City of Port Phillip
Advertised Plan 1 of 40

28-32 ALBERT ROAD, SOUTH MELBOURNE
DRAWING LIST

AMENDMENTS TO ENDORSEMENT PLANS:

Project Title
28-32 ALBERT ROAD
SOUTH MELBOURNE

Drawing Title
GENERAL ARRANGEMENT PLAN
LEVEL 24

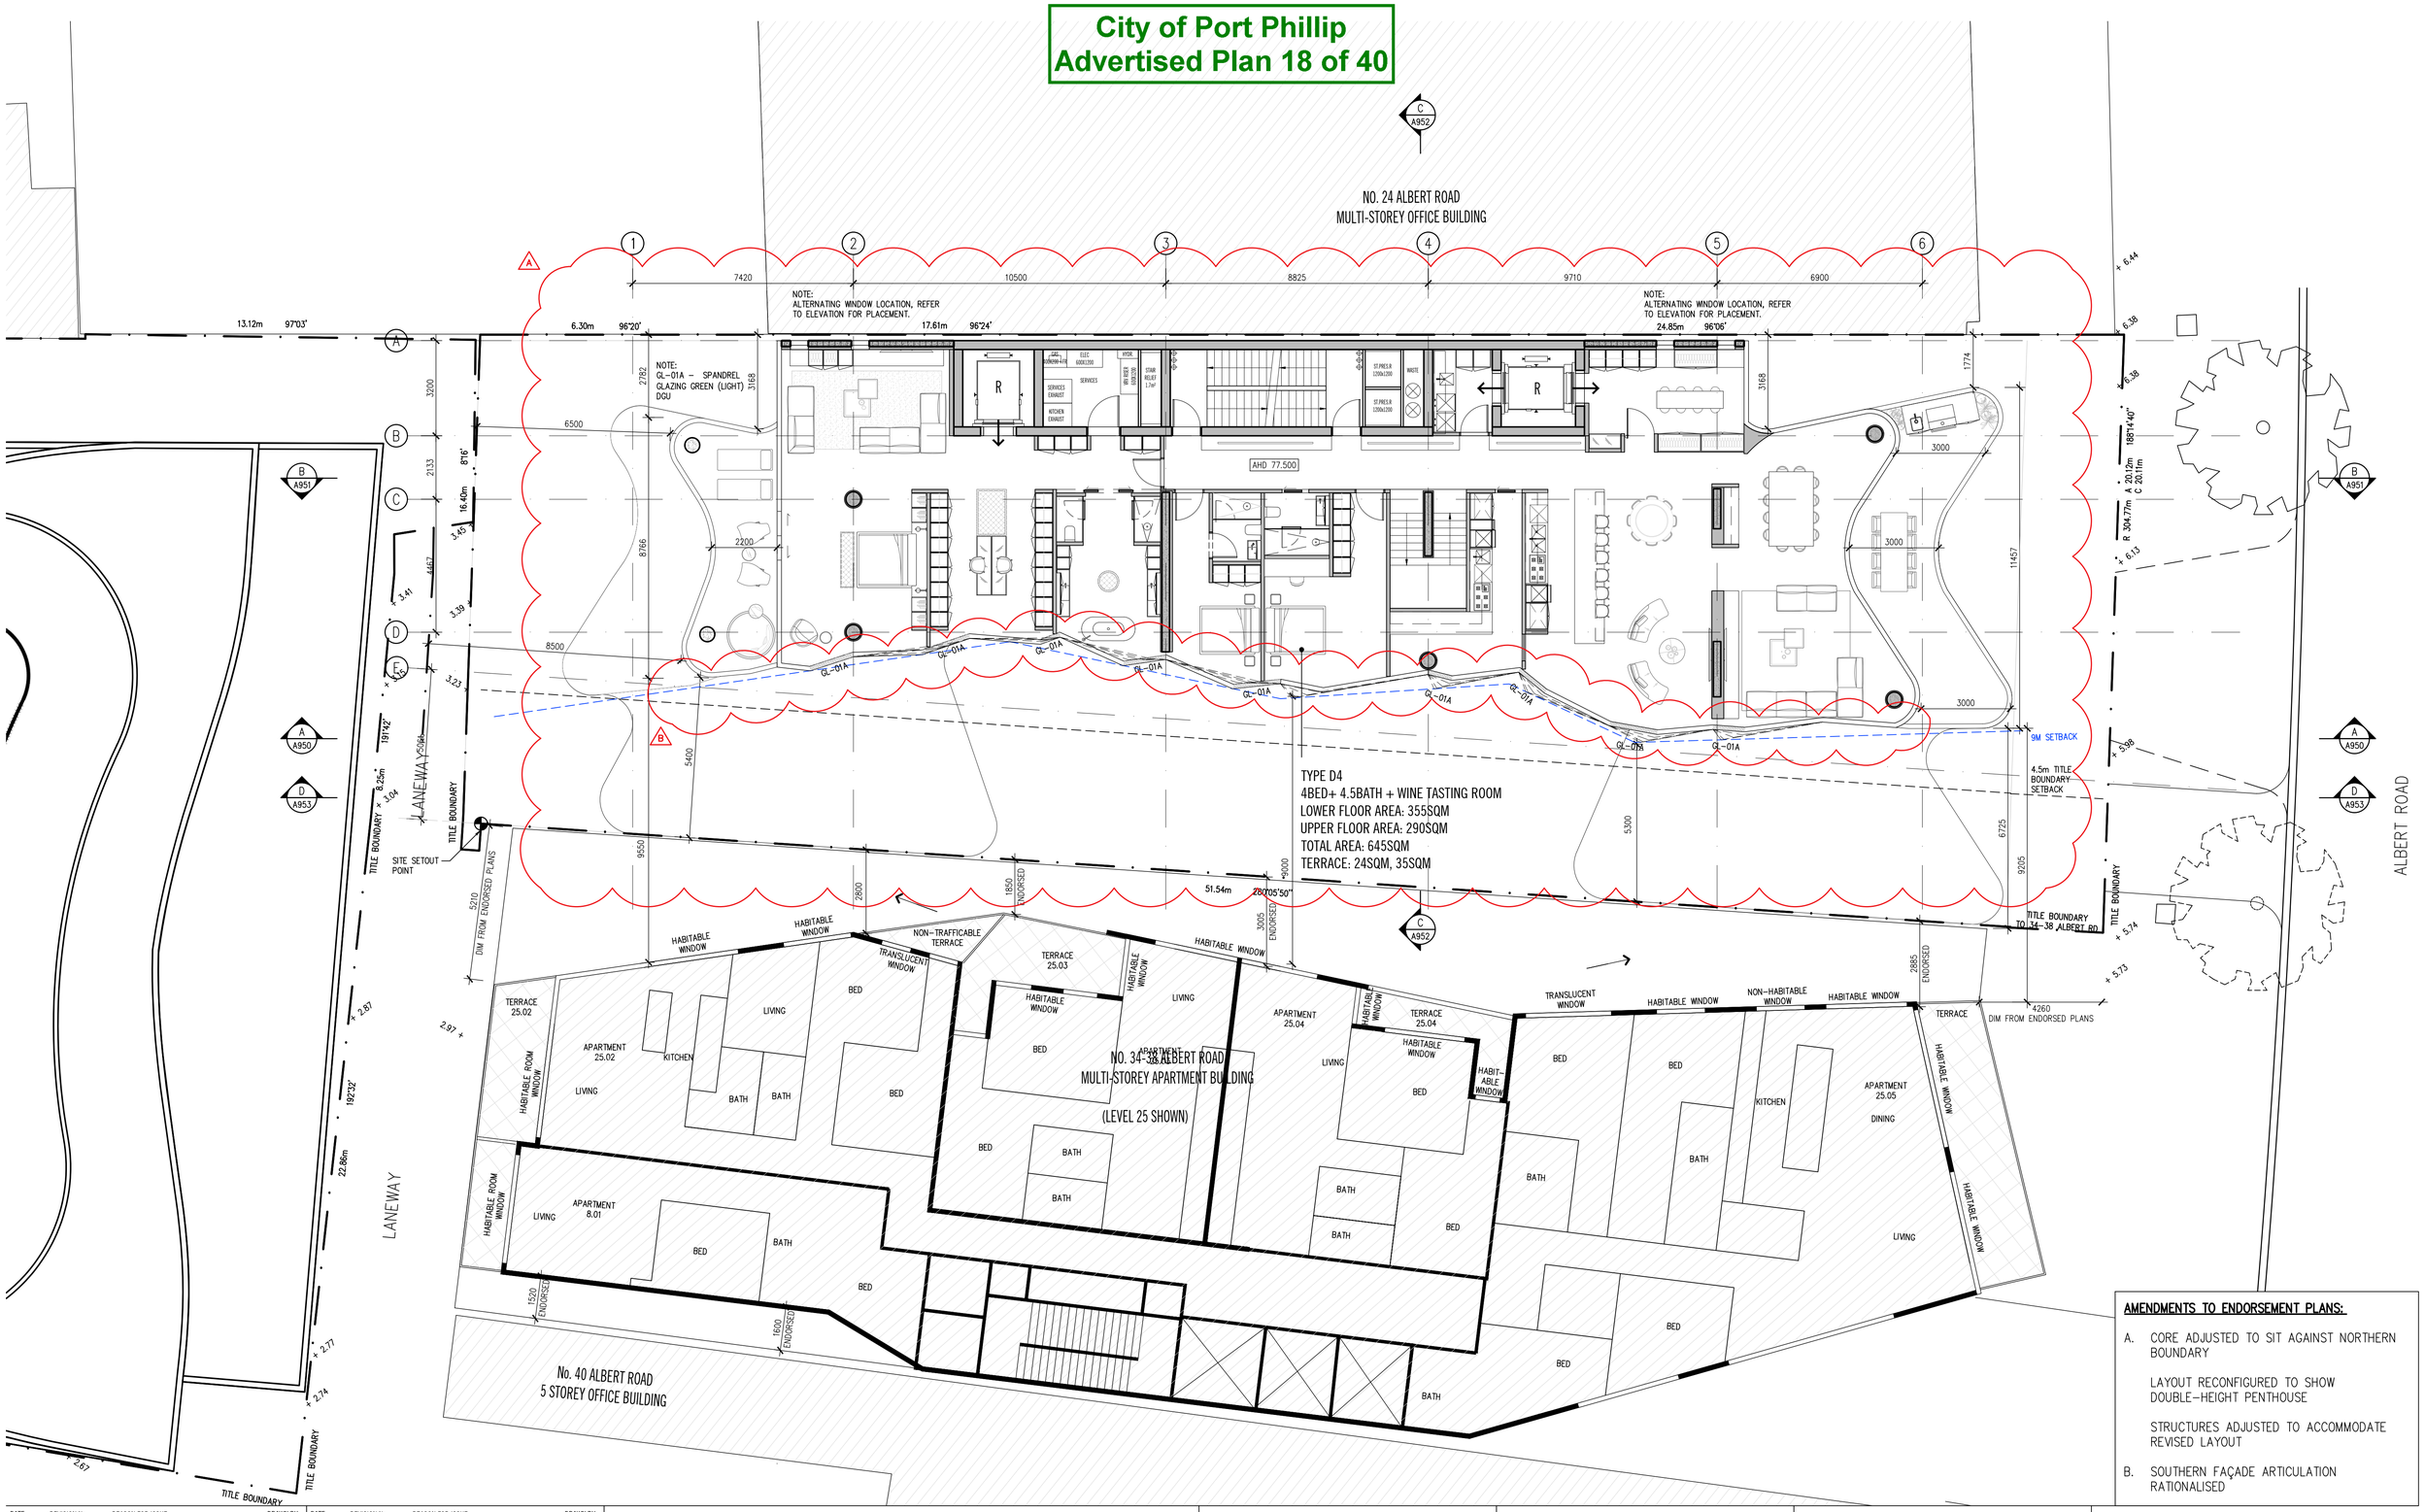
A. CORE ADJUSTED TO SIT AGAINST NORTHERN BOUNDARY

LAYOUT RECONFIGURED TO SHOW DOUBLE-HEIGHT PENTHOUSE

STRUCTURES ADJUSTED TO ACCOMMODATE REVISED LAYOUT

Drawing Title
GENERAL ARRANGEMENT PLAN
LEVEL 25

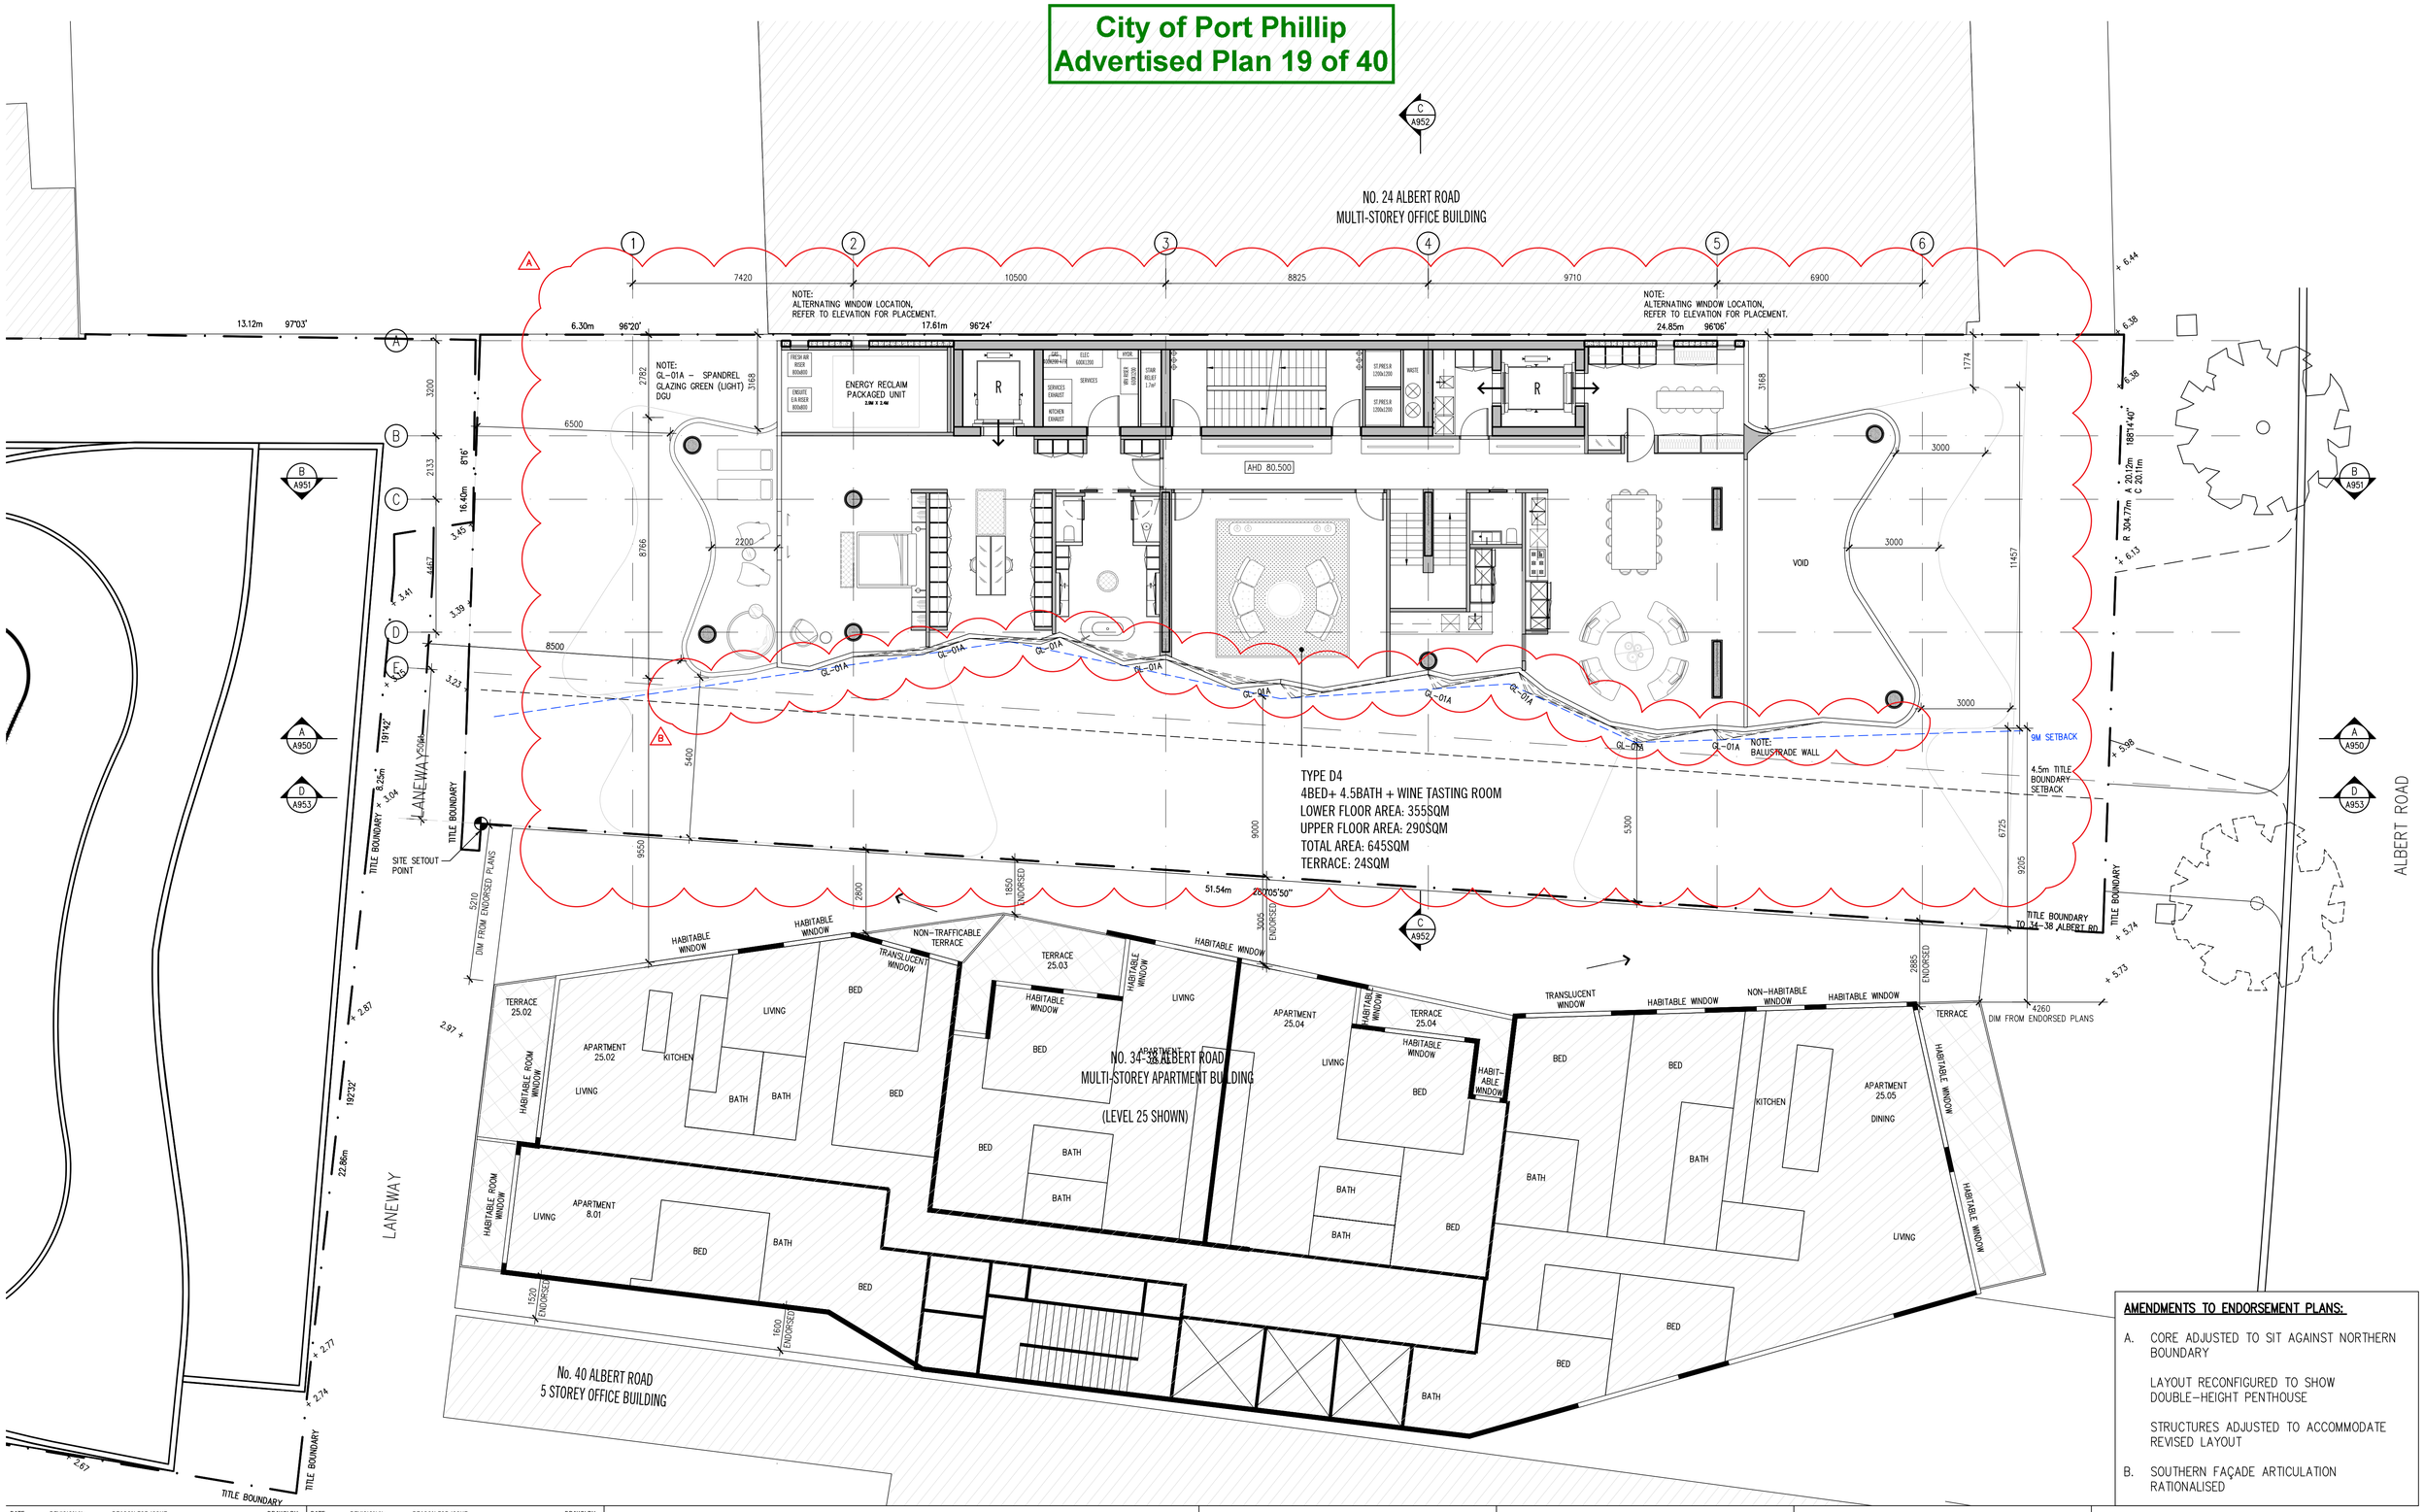
A. CORE ADJUSTED TO SIT AGAINST NORTHERN BOUNDARY

LAYOUT RECONFIGURED TO SHOW DOUBLE-HEIGHT PENTHOUSE

STRUCTURES ADJUSTED TO ACCOMMODATE REVISED LAYOUT

Drawing Title
GENERAL ARRANGEMENT PLAN
ROOF

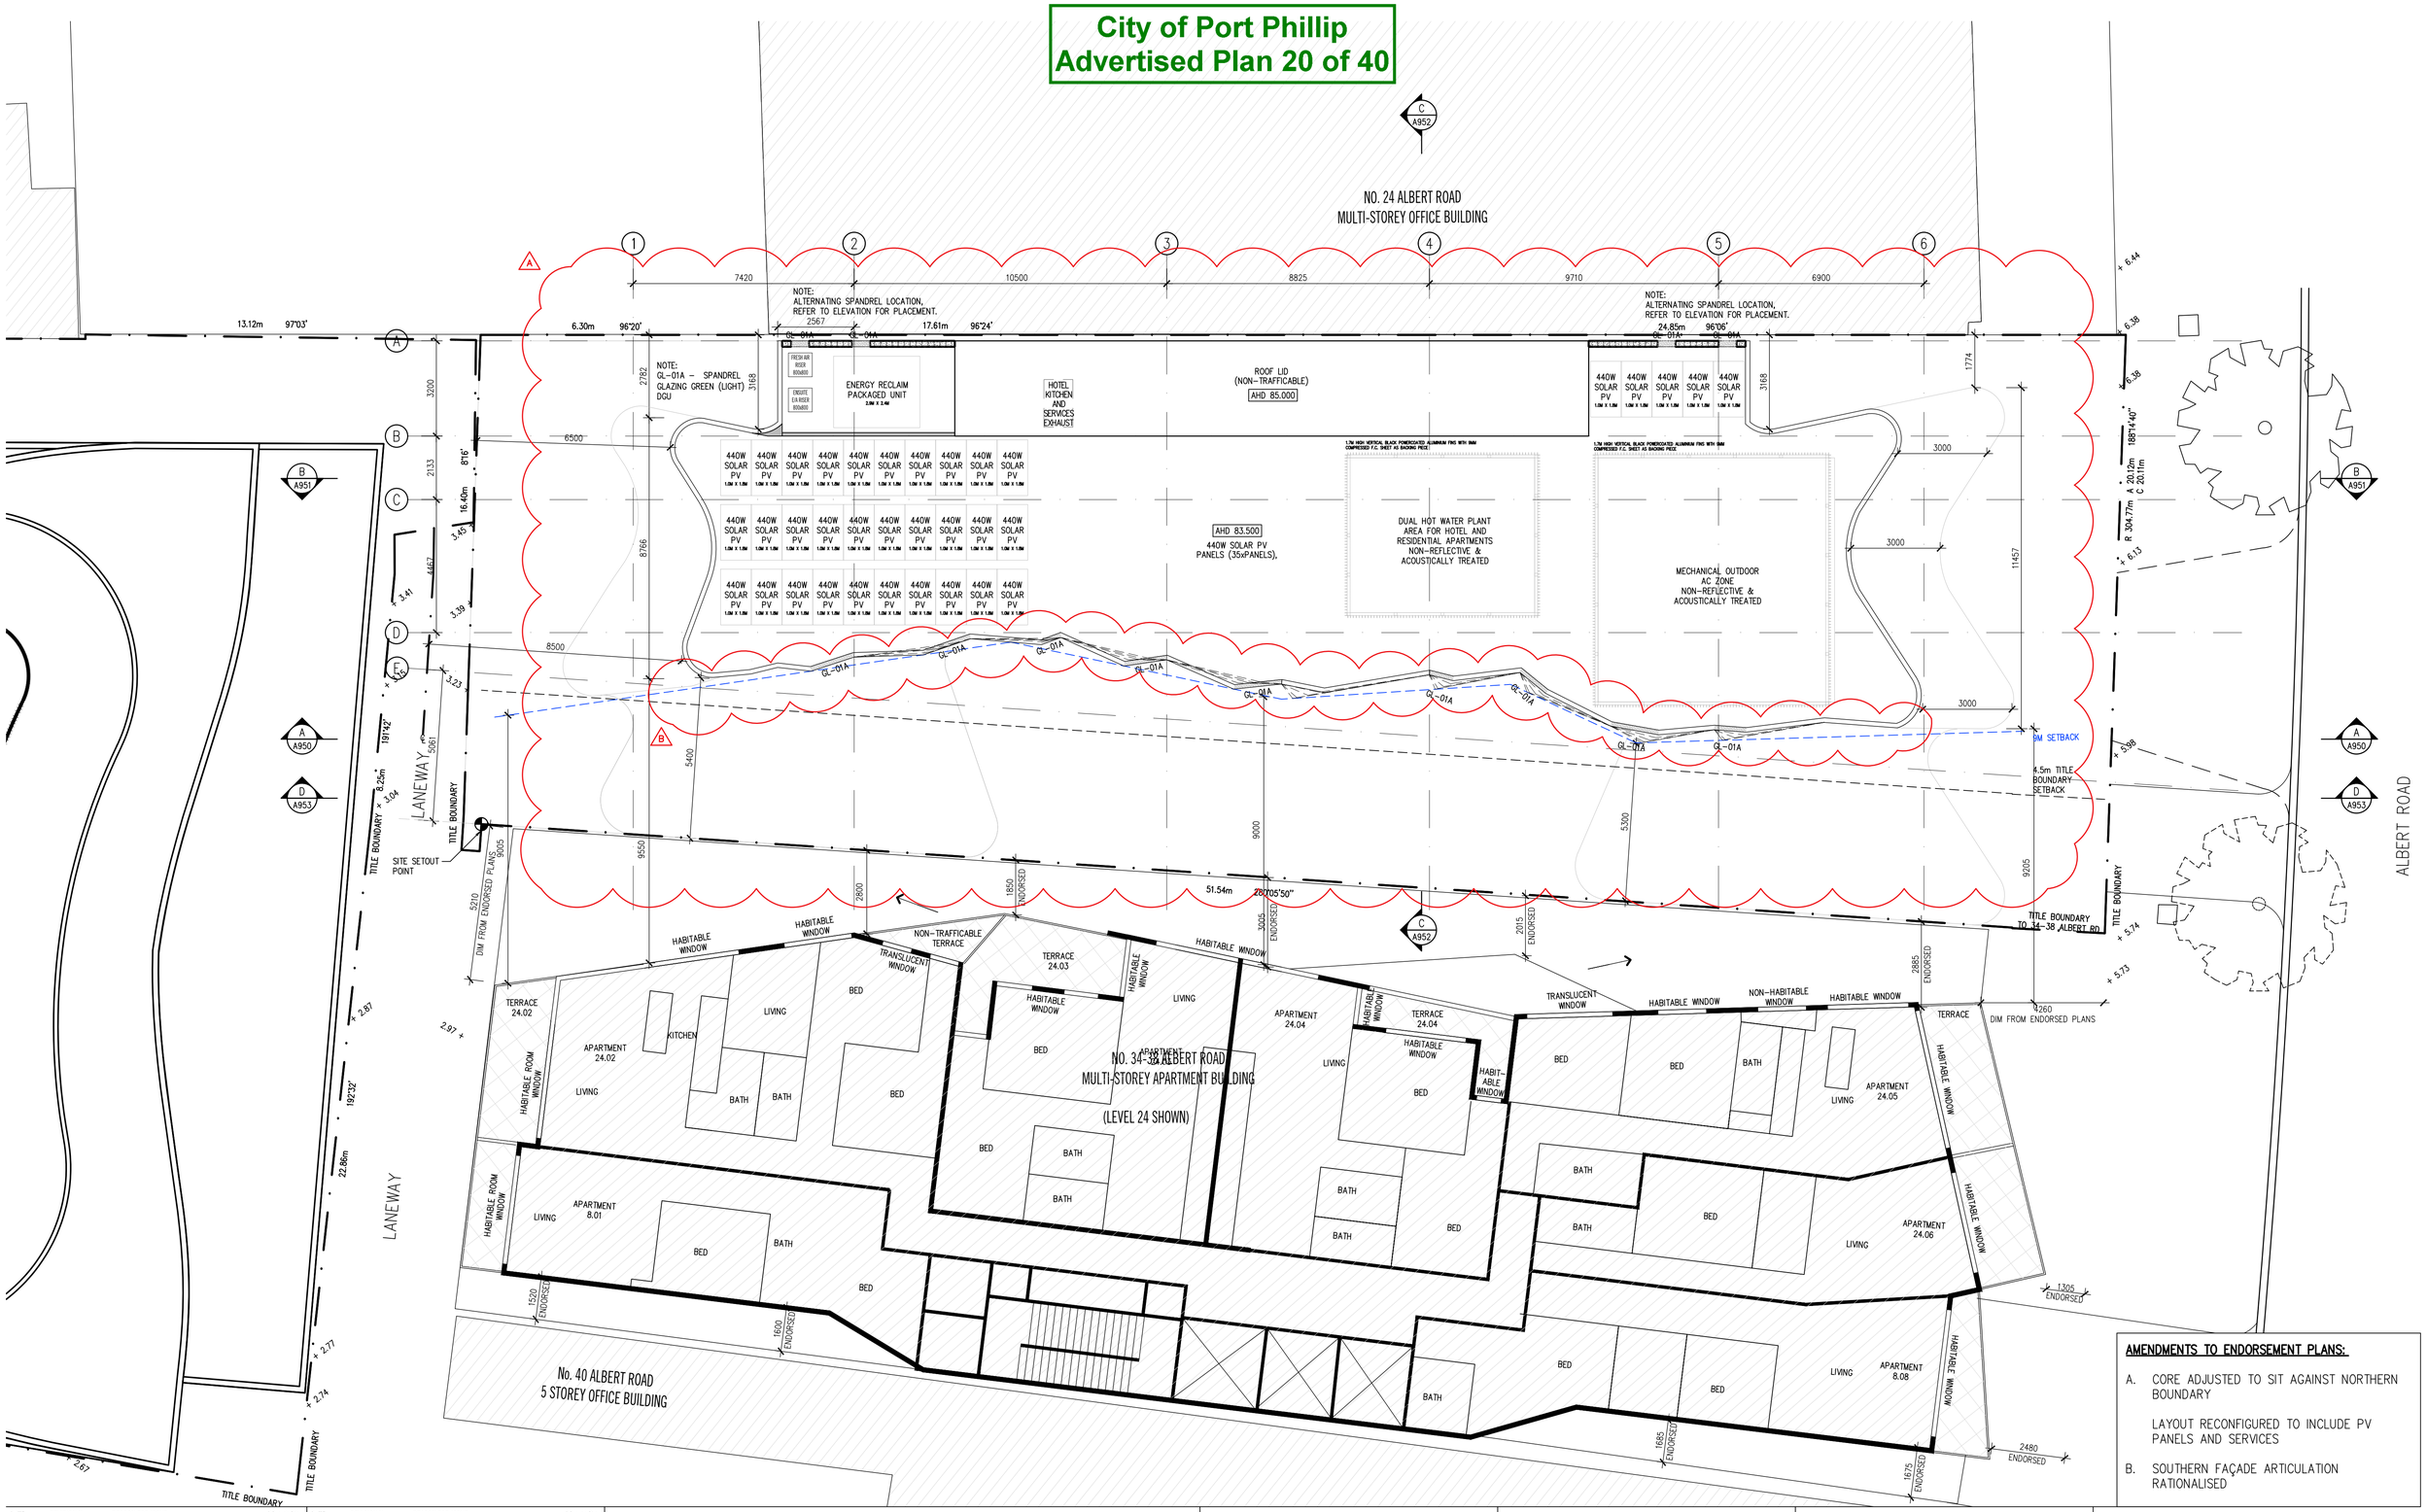
A. CORE ADJUSTED TO SIT AGAINST NORTHERN BOUNDARY
